COMMONWEALTH NATIONAL BANK SUBDIVISION

Engineering Comments: **FINAL PLAT COMMENTS** (should be addressed prior to submitting the FINAL PLAT for review and/or signature by the City Engineer):

APPLICATION NUMBER 1 DATE June 2, 2022

SITE PLAN

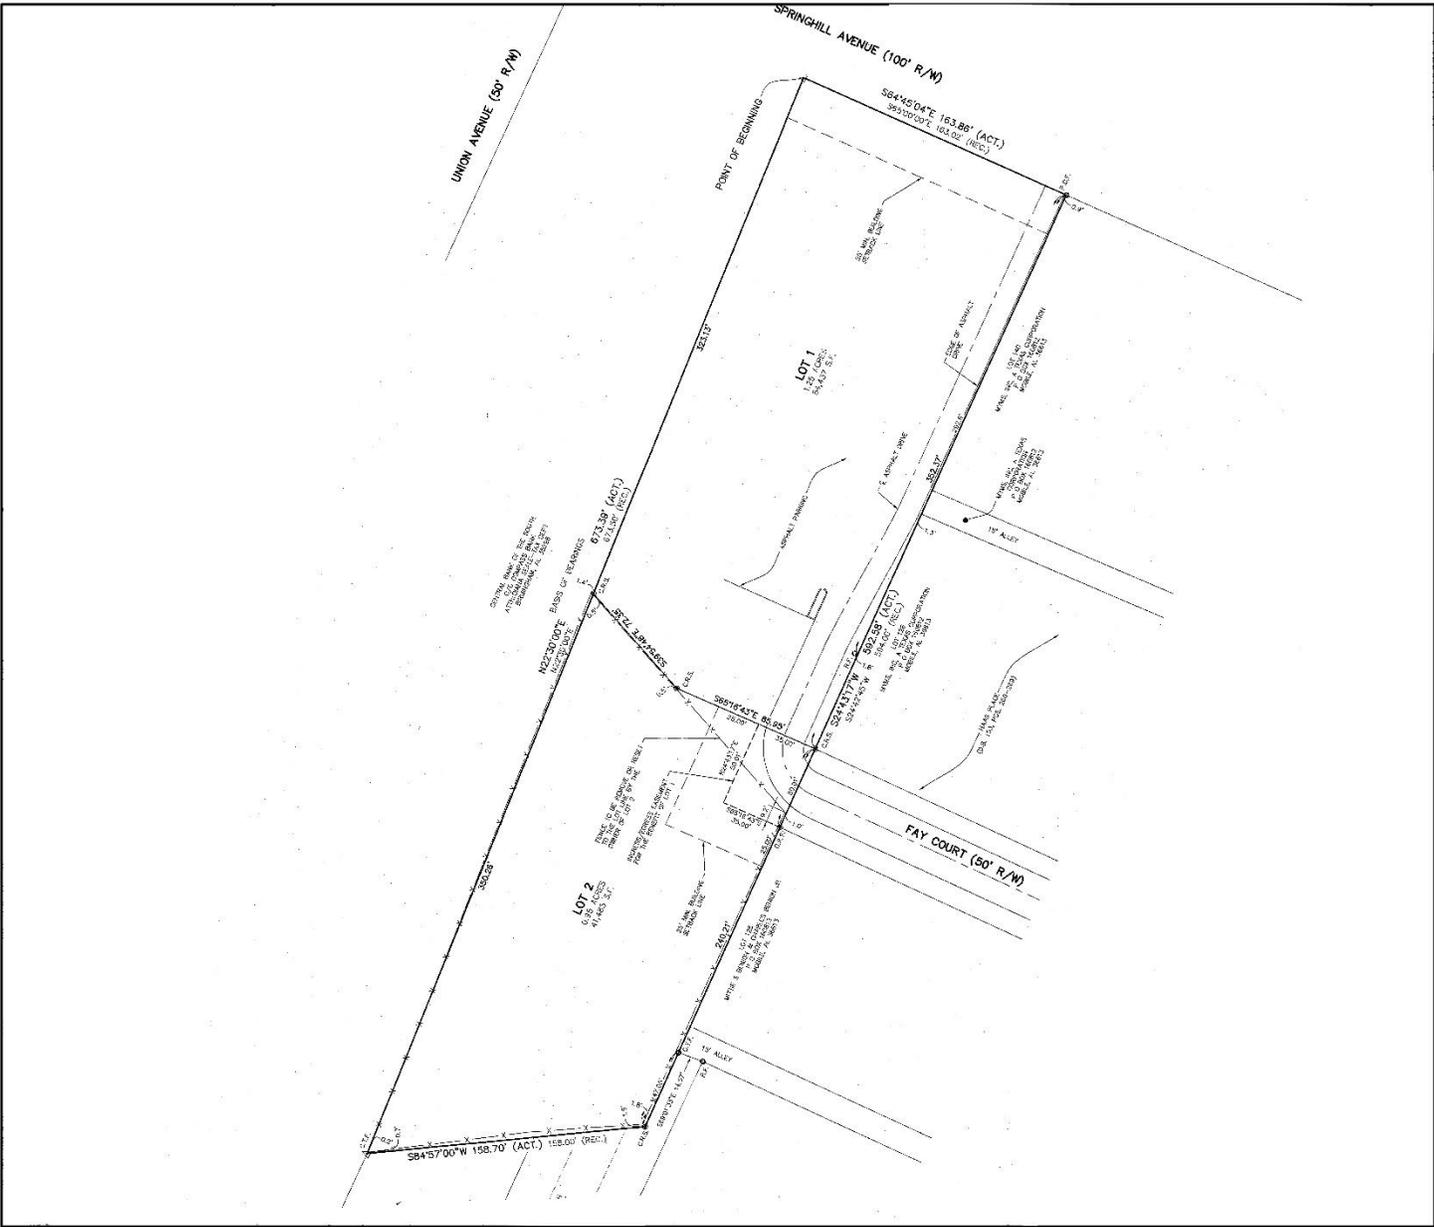
The site has frontage on Springhill Avenue, a major street included in the Major Street Plan, which has an existing compliant 100-foot right-of-way. The site has additional frontage on Fay Court, a minor street with curb-and-gutter, which has an existing compliant 50-foot right-of-way. As such, no dedication would be required for either street frontages. As on the preliminary plat, the right-of-way widths of Springhill Avenue and Fay Court should be retained on the Final Plat, if approved.

The plat indicates a 25-foot minimum building setback line along Springhill Avenue and where Fay Court abuts Lot 2. This should be retained on the Final Plat, if approved. The proposed lots meets the minimum size requirements of the Subdivision Regulations. As on the preliminary plat, the lot size label in both square feet and acres should be retained on the Final Plat, or a table should be furnished on the Final Plat providing the same information, if approved.

The proposed Lot 1 is developed with two existing curb cuts to Springhill Avenue and one existing curb cut to Fay Court. The preliminary plat illustrates an ingress/egress easement for the benefit of Lot 1 to access Fay Court, therefore a note should be placed on the Final Plat, if approved, stating no structures shall be constructed in any easement without permission of the easement holder. Proposed Lot 2 will only have frontage on Fay Court.

Springhill Avenue is an ALDOT controlled facility. As per the Traffic Engineering comments, the driveway number, size, location, and design are to be approved by ALDOT and Traffic Engineering and conform to AASHTO standards. If approved, a note should be required on the Final Plat stating these comments.

- 1) retention of the right-of-way widths of Springhill Avenue and Fay Court on the Final Plat;
- 2) retention of the 25-foot minimum building setback line along Springhill Avenue and Fay Court on the Final Plat;

- 3) retention of the lot size label in both square feet and acres on the Final Plat, or the furnishing of a table on the Final Plat providing the same information;

- 4) placement of a note on the Final Plat stating no structures shall be constructed within any easement without the permission of the easement holder;

- 6) placement of a note on the Final Plat stating the Traffic Engineering comments: *(Springhill Avenue is an ALDOT controlled Facility. Driveway number, size, location, and design to be approved by ALDOT and Traffic Engineering and conform to AASHTO standards.);*
